# ACCESS ASSESSMENT REPORT

## *BAE William Town – Precinct Entry Works*

Project Number: 117161

Revision: 2

#### Kerb Ramps

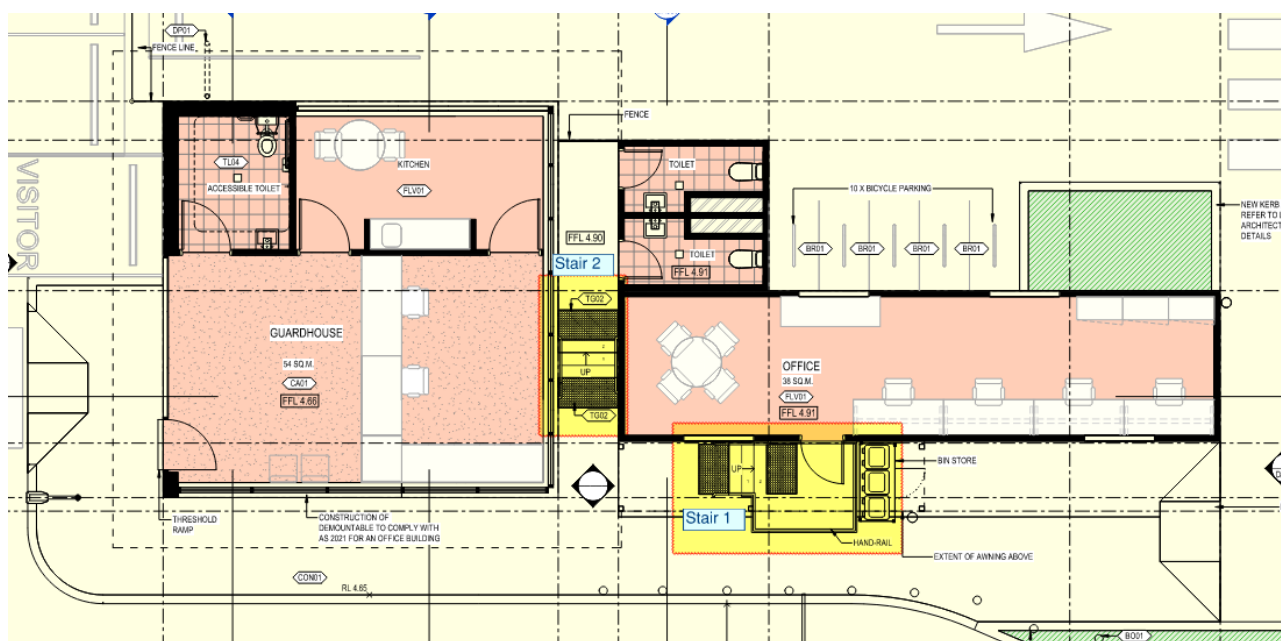
It is noted that kerb ramps are provided along the accessible path of travel where there is a level difference between the roadway and the pedestrian walkways.

The documents indicate that kerb ramps have been designed to meet the requirements of Clause 10.8 of AS1428.1-2009. Further adequate wheelchair turning spaces are afforded at the top of kerb ramp to allow wheelchairs to make 90 degree turns where changes in direction is intended.

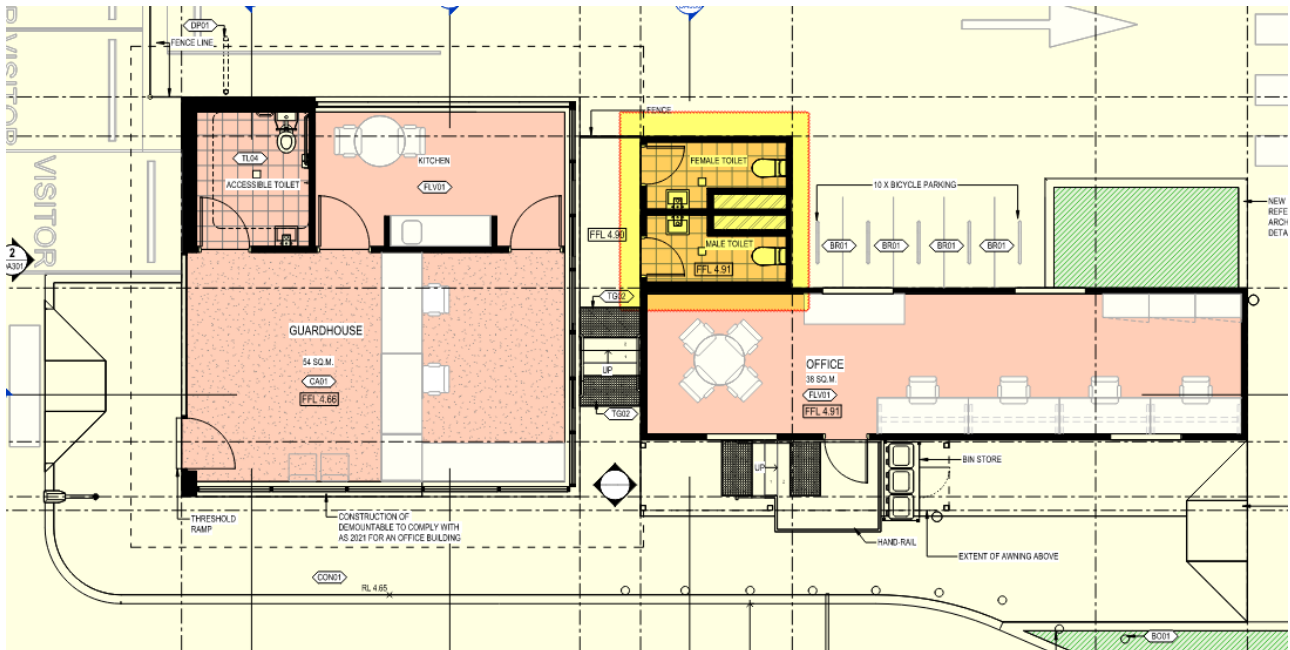
**Accessible WC** – The accessible WC is located within the Guardhouse and separated from the general amenities block located between the Guardhouse and Office buildings. While detailed information has not been provided at this stage of the development, the internal layout and compartment indicate that compliance under Clause 15 of AS1428.1-2009 is capable of being achieved.

**Ambulant WC** – The documents indicate the provision of two WC's located between adjacent to the Office building, behind the Guardhouse building.

Ambulant facilities are to be provided to meet the provision under this Clause. Standard WC to be converted to respective male and female ambulant WC designed in accordance with Clause 16 of AS1428.1-2009. This item is required to be detailed during post DA coordination.

It is anticipated that detailed 1:50 layout will be provided during post-DA coordination.
